SUBJECT: **Special Service Campaign (Recall) 80C – Phase 1**
 Certain 2004 - 2006 Model Year Sienna Vehicles Equipped w/Power Back Door (Power Rear Liftgate)

SPECIAL SERVICE CAMPAIGN (SAFETY RECALL) 80C

2004 THROUGH 2006 MODEL YEAR SIENNA
EQUIPPED WITH POWER REAR LIFTGATE STRUTS
(POWER BACK DOOR STAYS)

REAR LIFTGATE BRACKETS AND REAR LIFTGATE STRUTS

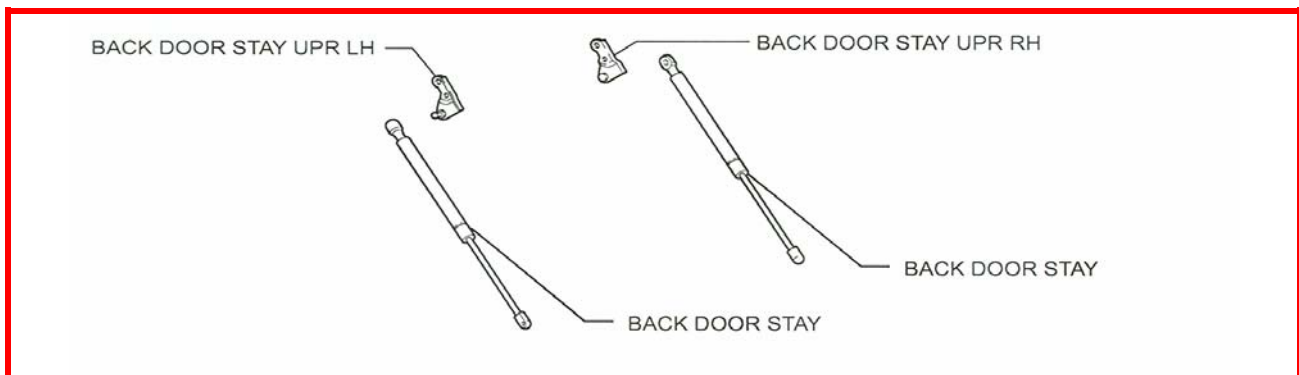
Toyota has determined that the gas struts used to help lift and support the Power Rear Liftgate in some Sienna vehicles are wearing out sooner than expected. As the gas struts deteriorate, the performance of the Power Rear Liftgate will begin to degrade, and the Power Rear Liftgate will operate more slowly than when the gas struts were new. If this condition is not repaired, the gas struts may not be able to support the weight of the liftgate when it is open. Eventually, the gas struts could deteriorate to the point that the liftgate will fall about ten inches after it reaches the fully open position, at which point the power motor will engage and power the liftgate to the fully closed position. This condition may cause injury to a person who is struck by the liftgate when it falls or when it is closing. Therefore, Toyota will conduct an SSC for the Power Rear Liftgate Struts.

1. VERIFY THE SHAPE OF THE REAR LIFTGATE MOUNTING BRACKETS

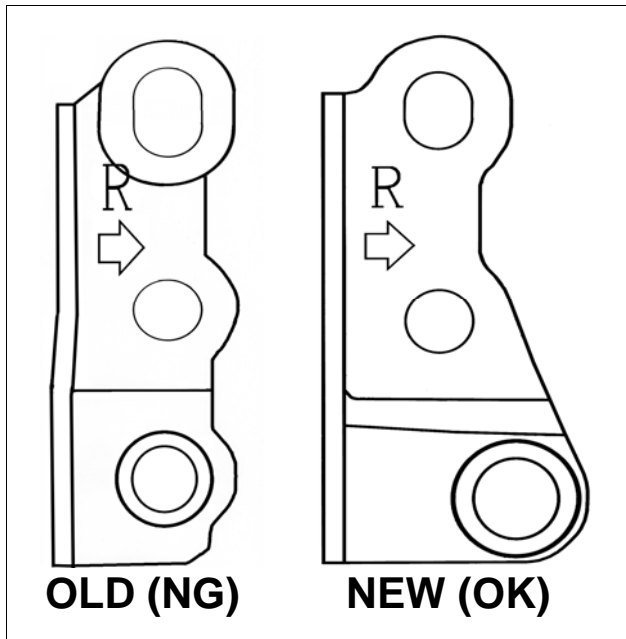
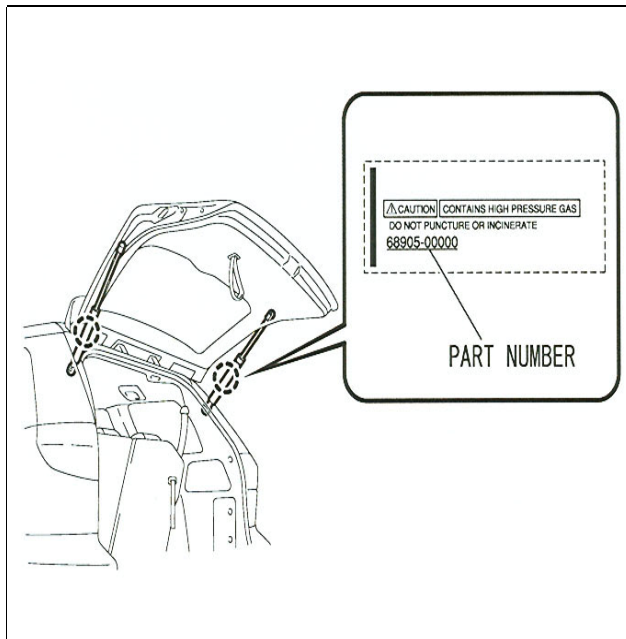
- Inspect the shape of both the Rear Liftgate Mounting Brackets (Vehicle side).
- If the new bracket type (wider shape) is found on both sides proceed to step 2.
- If the old bracket type (narrower shape) is found on either side, replace both struts and brackets using kit number 04008-011AE as outlined in TIS/Repair Manual.

NOTE: Failure to replace the old style brackets will cause premature wear to the new liftgate struts.
